SUBARU

NUMBER: 03-82-18

SERVICE INFORMATION BULLETIN

SUBJECT: Clutch Release (Throw-Out) Bearing-

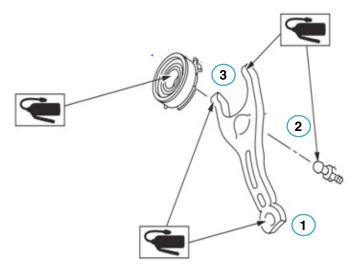
- To avoid customer concerns of a post-repair creaking, squeaking or clicking sound possibly accompanied by increased pedal effort (stiffness) when operating the clutch pedal, always thoroughly clean, inspect for signs of wear and re-lubricate the clutch release components. Any worn components identified should be replaced. For example: see the photos below which show excessive wear on areas of the release fork which was the root cause of a squeaking sound heard while the engine was running.
